# 1992 Corvette: Service Bulletin: Hood Latch Striker Bolt

**Subject:** HOOD LATCH STRIKER BOLT (USE PAST MODEL SERVICE PARTS)

**Model and Year:** 1992 Corvettes, Prior to VIN Breakpoint N5100919

**Bulletin Number:** 92-43-10 - (11/07/1991)

VIEW A

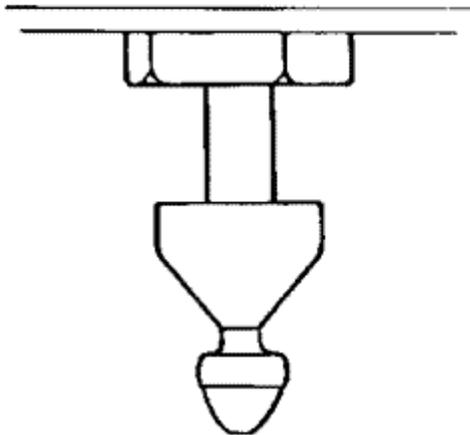
1. Raise hood to full open position. 2. Remove pop up spring and attaching bolt from bracket and discard (see View A). 3. Install new attaching bolt in position, tighten and torque to 27 N.m (20 lbs. ft.). 4. Loosen the locking nut on the striker latch bolt, remove bolt and nut from hood bracket, disassemble nut from bolt and save the nut for use on the new striker bolt. **DISCARD THE ORIGINAL STRIKER BOLT.** 5. Preassemble the new bolt, retainer, spring and original lock nut (see View B).

VIEW B — PRODUCTION

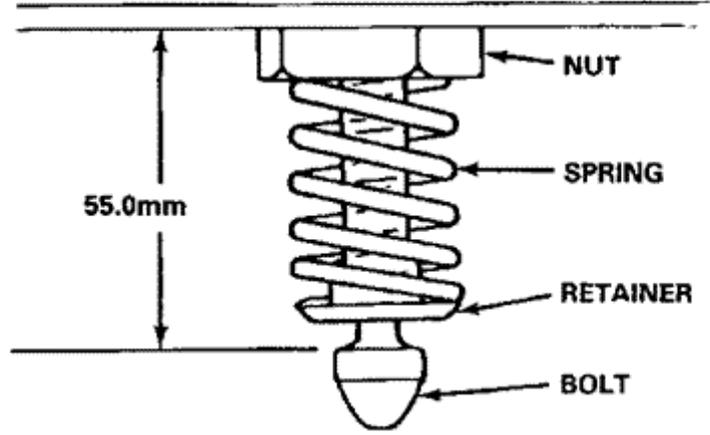
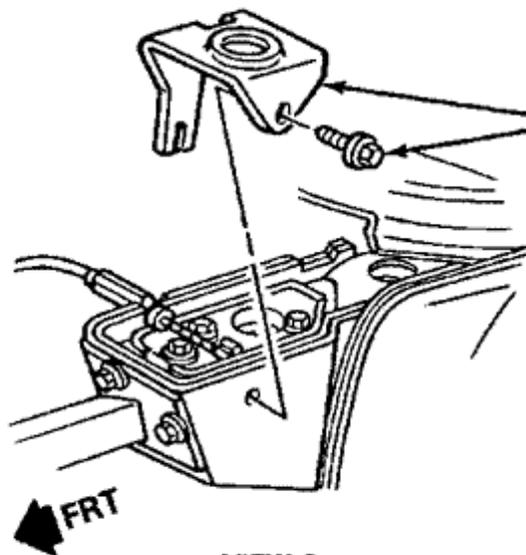
**NOTE:** The nut has a cavity on one side to act as spring seat.

6. Install the new striker bolt assembly to the bracket on hood, set initial

height as indicated on the illustration and tighten the locking nut. 7. Remove the outer attaching bolt for the spring seat (View C), loosen the inner attaching bolt and remove and discard the spring seat and outer attaching bolt. 8. Tighten the inner attaching bolt and torque to 25 N.m (18 lbs. ft.), see View C, inside View. 9. Carefully lower hood, check for latching and flushness conditions and adjust as required.
